Jerat Shirt Limited

Plot - 188/189, Nasirabad I/A, Baizid, Chittagong.
(22.387914N, 91.812415E)
9th March 2017

Observations

Column and beam layout plan

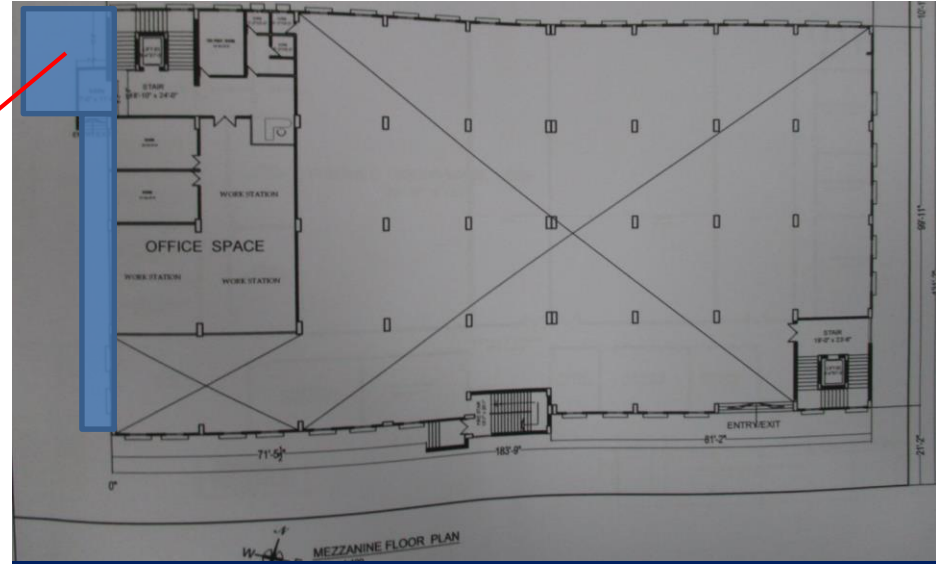
Mismatch's in as-built drawings of production building

Floor beam missing

Additional stair columns

Two number of columns with beam at south side stair were not shown in drawing. Again, two additional columns with a beam were shown in drawings but not found on site. factory engineer to survey the structure and update the as-built drawings.

Floor layout plan

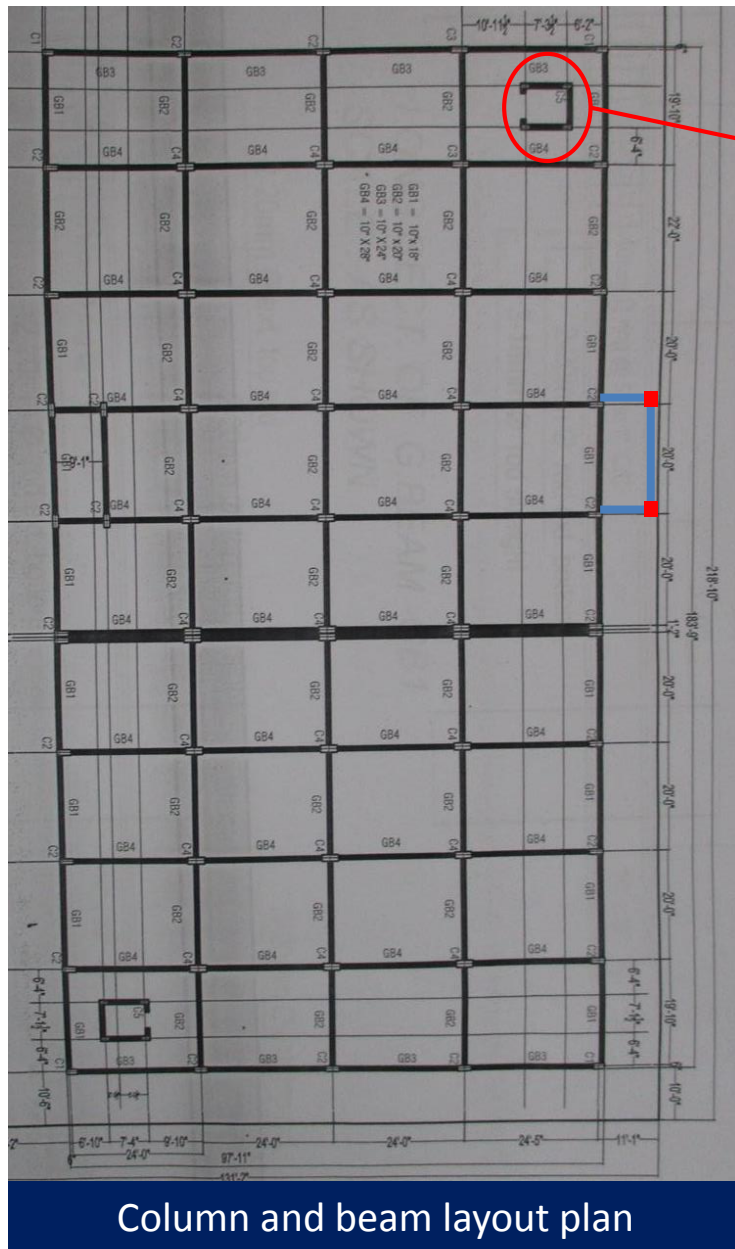
The porch and the cantilever beam and slab not shown in as-built drawings.

Column and beam layout plan

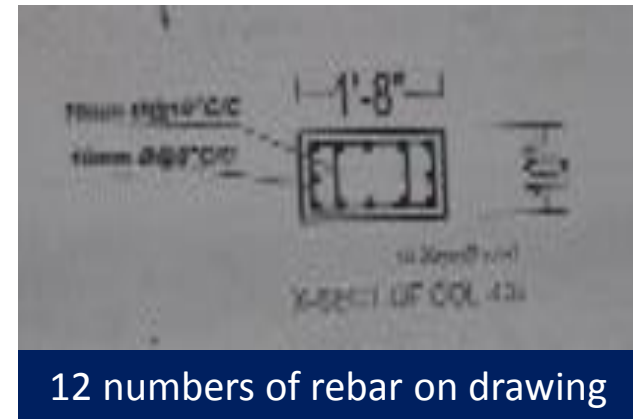
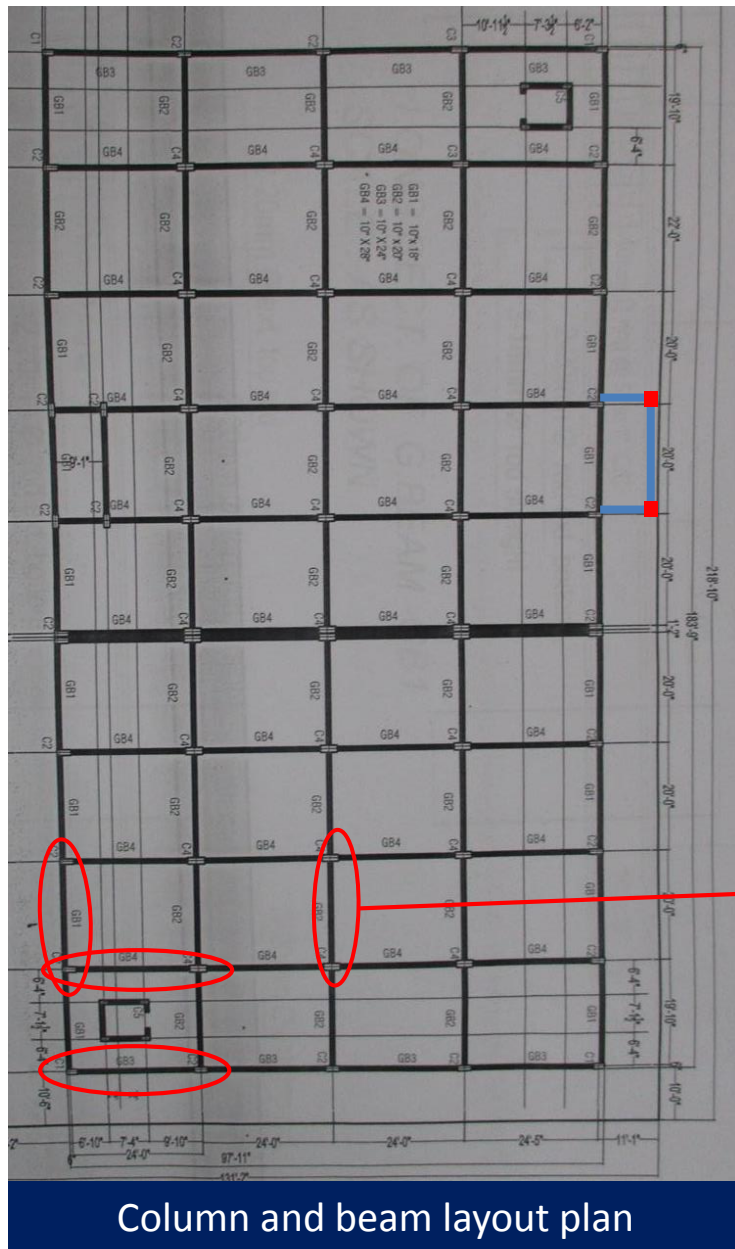
10 numbers of rebar found on column C5

12 numbers of rebar on drawing

10 numbers of rebar were found inside for the column C5 where drawing shows 12 numbers.

LONG SECT. OF R.BEAM-RB4

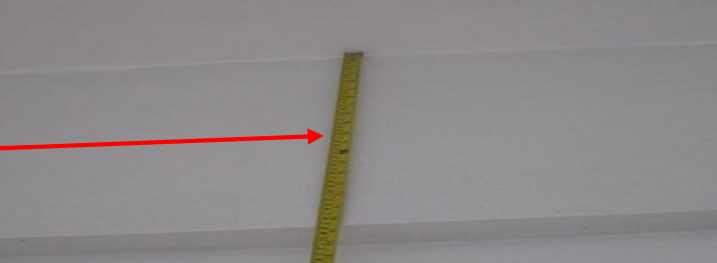
The dimension of floor beams for RB2, RB3 and RB4 does not matched with as-built conditions.

Provided as-built drawing does not matched with as-built conditions. Floor built-up, roof top water tanks, cantilever slab, porch and some internal partition walls were not mentioned in as-built drawings. Factory engineer to update the as-built drawings as per actual scenario.

Floor & Column Layout Plan

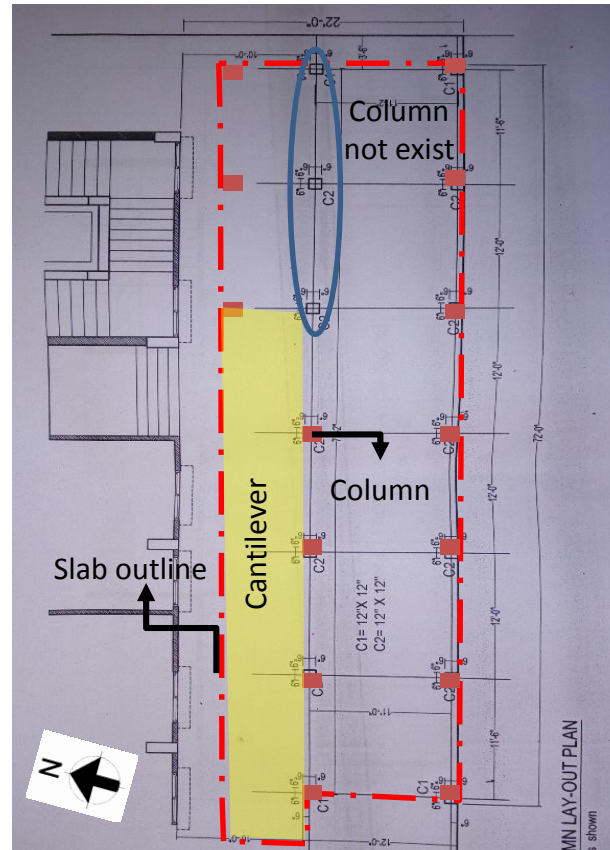
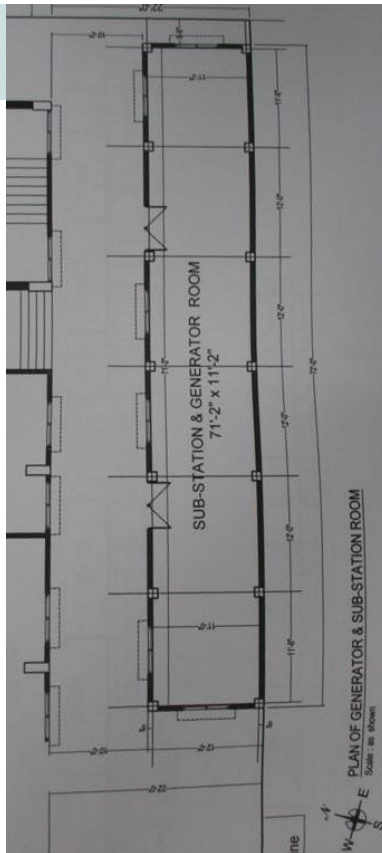
Insufficient as-built drawing of utility building

As-built drawing of Utility Building does not match with as-built conditions.
The column dimension and the grid spacing not match's with drawings.
Factory engineer to update the as-built drawings to the as-constructed status.
